JOINT REGIONAL PLANNING PANEL (Hunter and Central Coast)

Supplementary Council Assessment Report

Panel Reference	2016HCC024
DA Number	49578/2016
Local Government Area	Central Coast Council
Proposed Development	Proposed mixed use commercial and shop top housing development with 184 units, including the demolition of existing structures and staged construction.
Street Address	Lot: 8 SEC: 1 DP:1591, Lot 9 SEC: 1 DP: 1591, Lot: 10 SEC: 1: DP: 1591, Lot: 11 SEC: 1 DP: 1591, Lot: 12 SEC 1 DP: 1591, Lot: 13 SEC: 1 DP: 1591 No. 321 Mann Street, GOSFORD, No. 325 Mann Street, GOSFORD & No. 331 Mann Street, GOSFORD.
Applicant	Mann St Enterprises Pty Ltd
Owner	Mann St Enterprises Pty Ltd
Date of DA Lodgement	1 April 2016
Number of Submissions	Five (5)
Recommendation	Deferred Commencement Approval, subject to conditions
Regional Development Criteria - Schedule 7 of the State Environment Planning Policy (State and Regional Development) 2011	Capital Investment Value > \$20M and lodged before 1 March 2018.
List of all relevant 4.15(1)(a) matters	<ul style="list-style-type: none"> • <i>Environmental Planning & Assessment Act 1979</i> (EP&A Act) • <i>Local Government Act 1993</i> (LG Act) • <i>Roa

Figure 1: Photomontages showing increased slot between tower forms

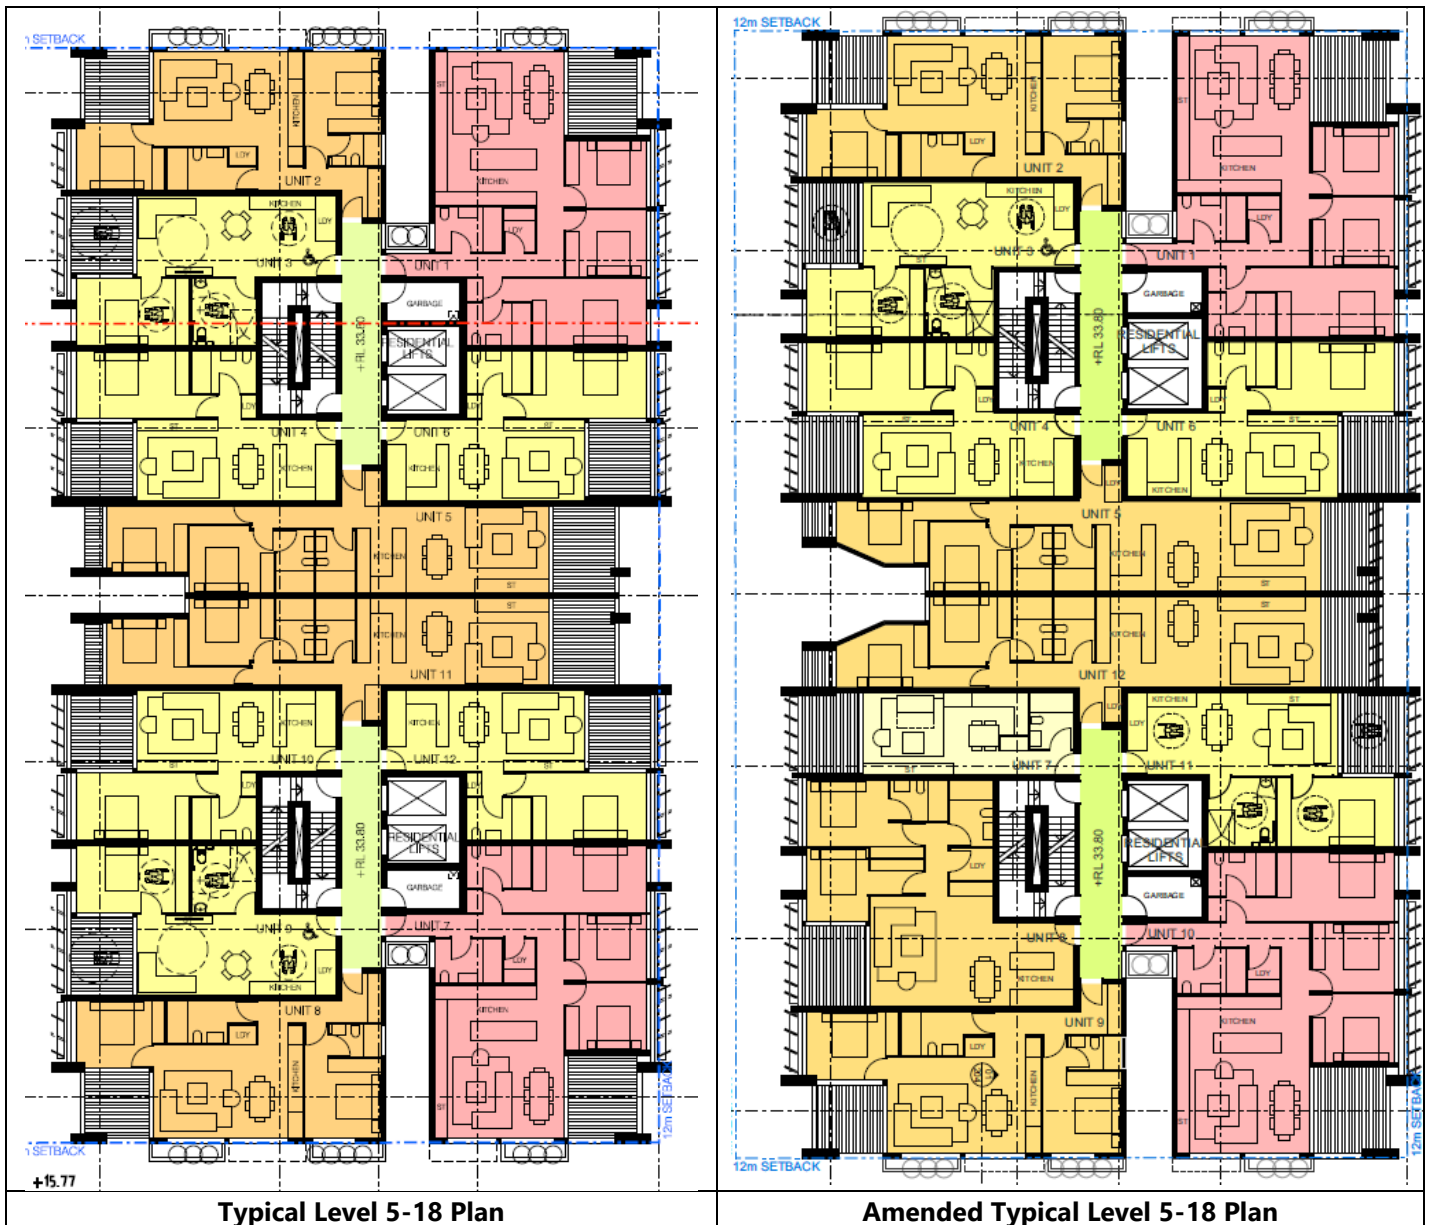
Panels comments: Provide amended plans that increase the size of the slot between the two tower forms (mid units fronting Mann Street) to enable the tower form to read more as two separate tower forms from the Mann Street frontage.

Applicants comments: The slot between two buildings, from being 1.6 meters before it is almost triple increased into 4.1 meters. As can be seen in floor plans and especially in the visualization from Mann Street, the proposal distance of 4.1 meters enables from the pedestrian level visual perception of two volumes.

Council comments: The increase in the width of the slot from 1.6m to 4.1m creates a greater visual separation between the tower forms. This is demonstrated in Figure 1 below. The impact of the increased slot on the floorplan is shown in Figure 2.

Figure 3: Podium level showing change to Communal open space

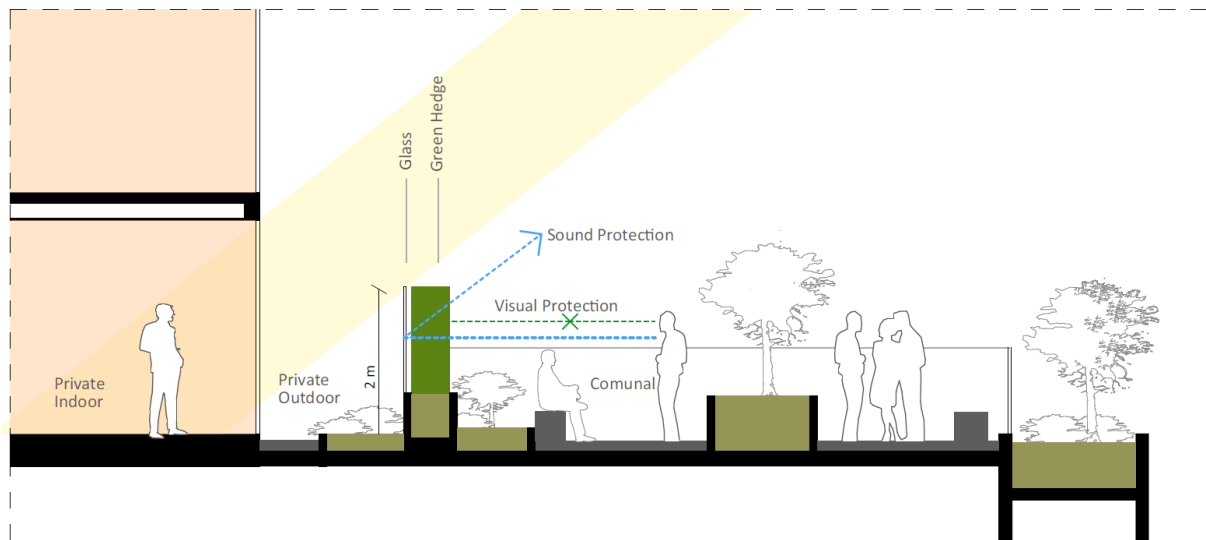
Panels comments: Level 4 is to be redesigned to achieve improved aural and visual privacy to all residential units while maintaining reasonable access to sunlight to living rooms and private open space areas for those apartments adjoining the communal open space areas.

Applicants Comments: In order to achieve substantial improvement aural and visual privacy to the residents in level 4, without compromising the access to sunlight to living areas and private open space, the communal area on the eastern side is proposed to be removed. This area will be left to the occupants of the respective apartments, which will be used for gardening.

In regard to the southern side, achieving sufficient visual and acoustic privacy to residents of the dwellings 8 and 9 adjoining the communal open space to the south, it is proposed a green hedge wall in height of 2 m following with glass layer in the inner side. While the former protects the two dwellings from visual permeability the second plays a sound protection role.

Council Comments: Combined with the other design amendments discussed further below the amendments to the podium level result in improved aural and visual privacy to the apartments on this level.

Figure 5: Section Through proposed planters

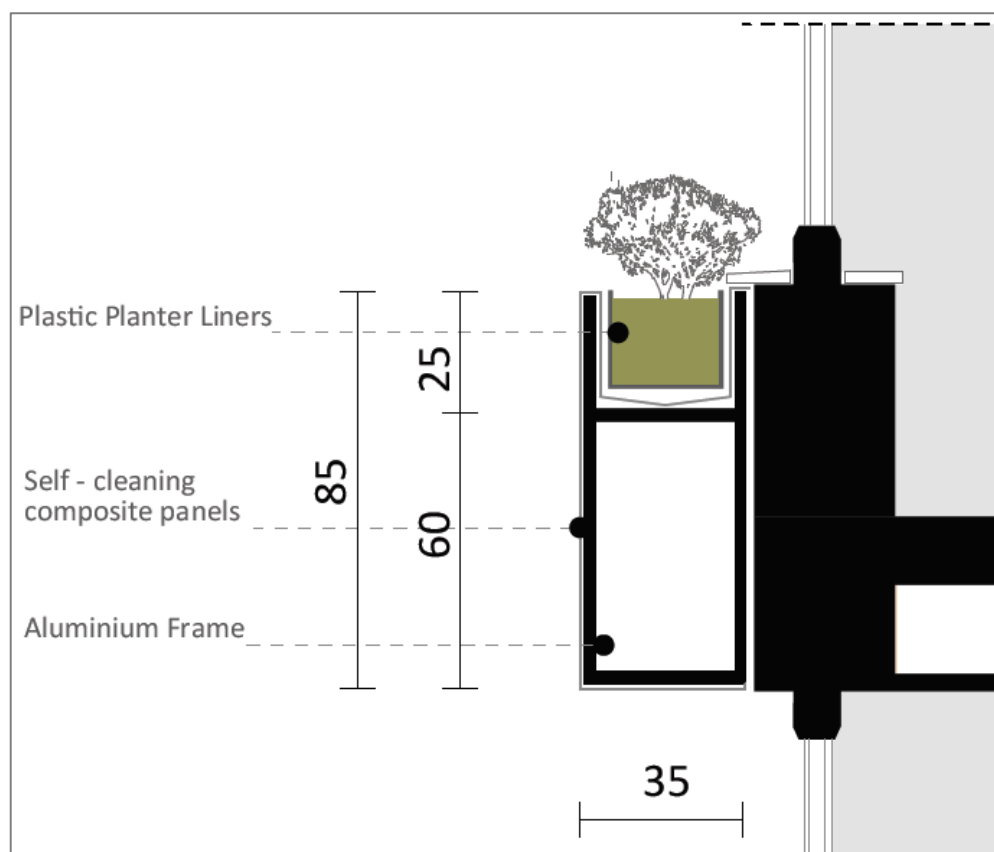
Panels comments: Further details are to be provided for the proposed architectural and landscape design of the north and south façade planters, including but not limited to planting schedule including consideration of soil depth, access to sunlight and wind conditions,

operational and maintenance details and architectural planter box façade design details. Consideration of an alternative façade treatment that exhibits design excellence may be submitted for further assessment by Council's Architect as an alternative to the planter boxes.

Applicants Comments: The alternative architectural proposal design for the southern and northern facade, as can be seen in Detail D1, consists of lightweight boxes made out of nano self-cleaning composite aluminium. Instead of being filled out with soil as initially proposed, on the new proposal, the inner side is filled with common shallow plastic liner boxes, which can be easily replaced and maintained by the residents themselves. The external dimensions of planter boxes have been remodelled now are much thinner around 350 mm. Otherwise, the nano self-cleaning composite panels with superior self-cleaning performance, antipollution property, acid resistance, and alkali resistance. The nano self-cleaning panel is an updated decorative material. It has a hydrophobic and lipophobic surface, which makes it more repellent to water and dirt.

Council Comments: The planter details are shown on the amended drawings and as shown in Figures 5 and 6. While individual occupant management of the proposed planters will not result in a unified landscaped façade, some variation is acceptable and the planter boxes themselves add articulation and visual interest to the northern and southern facades.

It is noted that an updated landscape plan has not been provided. A condition is recommended to require an updated landscape plan, that aligns with the submitted landscape plans as well as the amended plans. The condition will require plants for the planter boxes to be identified and are to be low maintenance, specific to the two aspects (i.e. north and south elevations) and appropriate for the available soil depth.

Figure 7: Ground floor plan showing waste transfer route

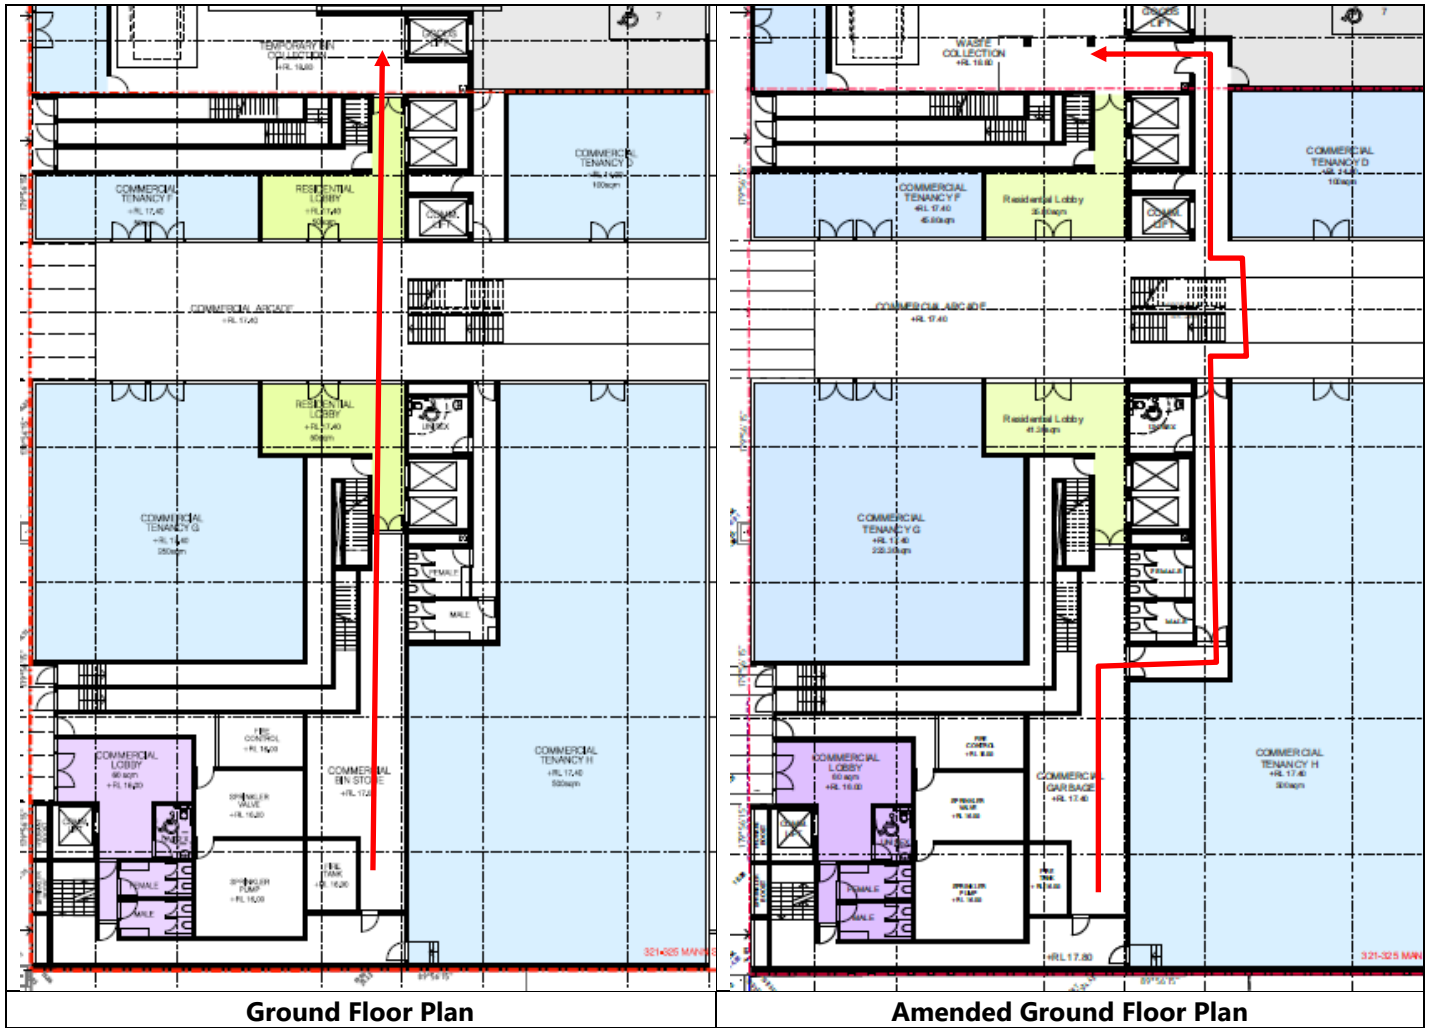
Waste Modifications: The applicant has also made minor modifications to the ground floor plan, with the addition of service corridor to allow for commercial bulk waste bin transfer through the service corridor rather than through the residential lobbies. This is demonstrated in Figure 7. Council's Waste Management Assessment Officer has reviewed the amended architectural plans and Waste Management Plan and is satisfied with the proposed arrangement. Appropriate conditions have been recommended.
